MIL-I-82437(OS)
Amendment 3
29 April 1969
Superseding
Amendment 2
14 August 1968

MILITARY SPECIFICATION

IGNITER

This amendment forms a part of Military Specification MIL-I-82437(OS) of 10 May 1966 and has been approved by the Naval Ordnance Systems Command, Department of the Navy

FIGURE 1. PRESSURE-TYPE ENVELOPE

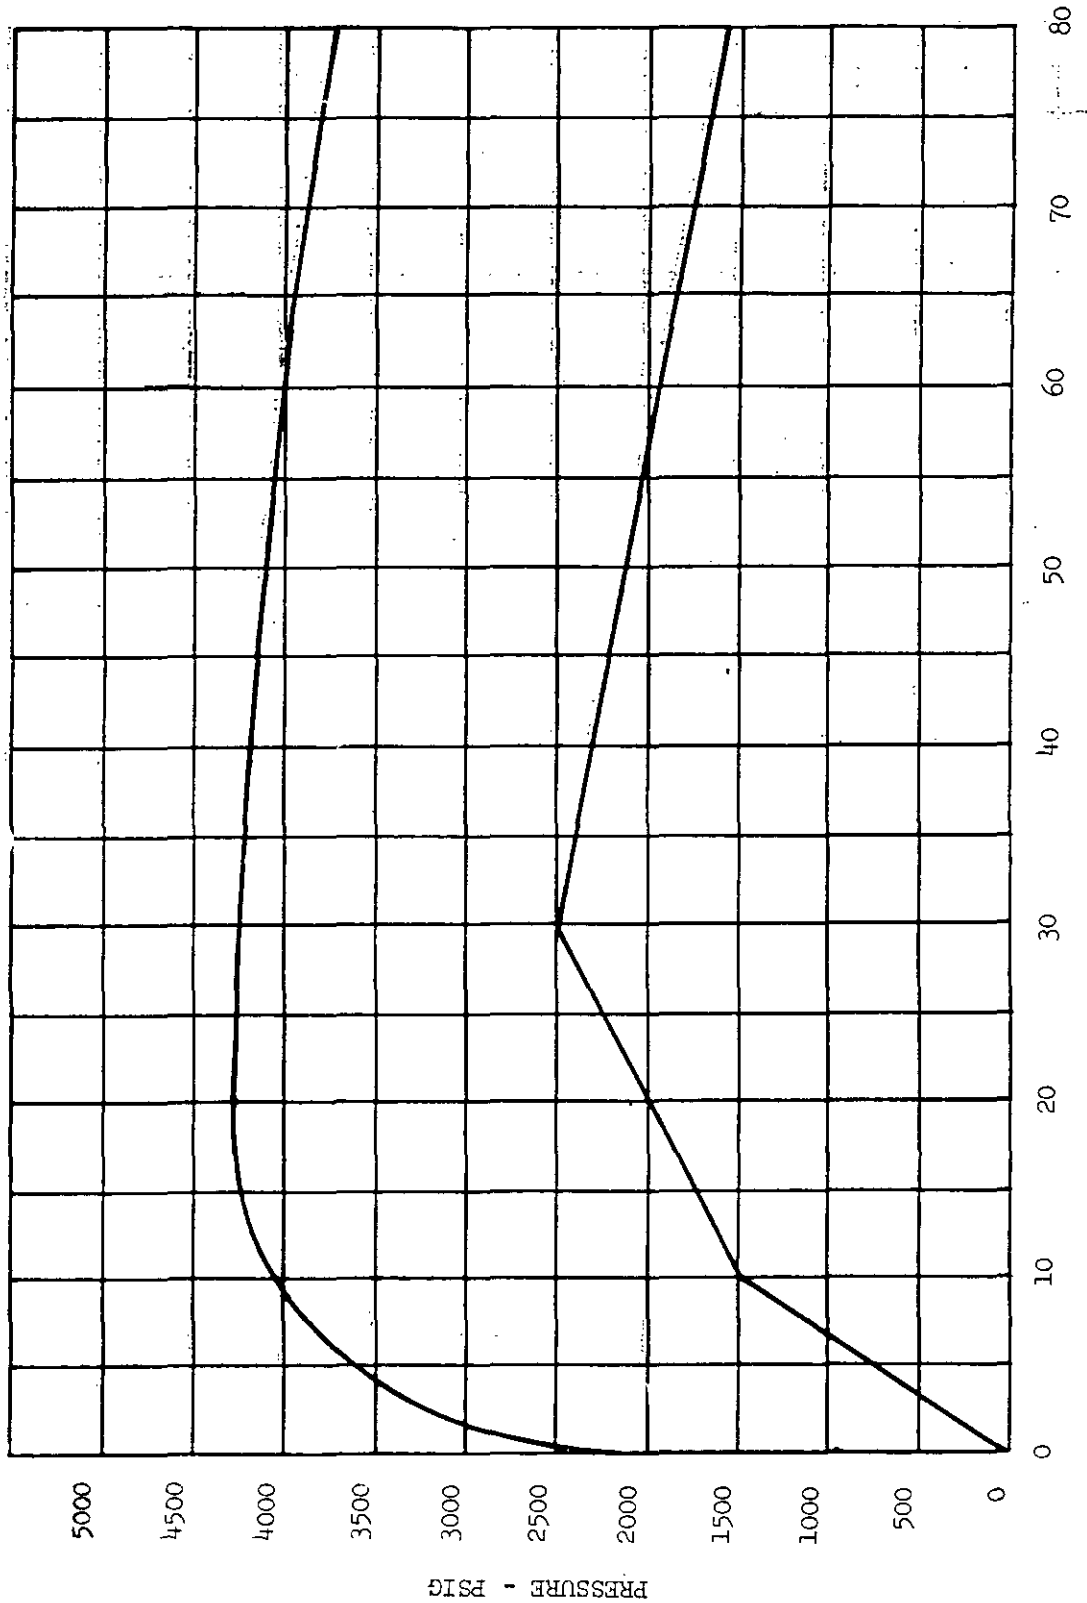
Page 29. Replace Figure 1 with new Figure 1, attached.
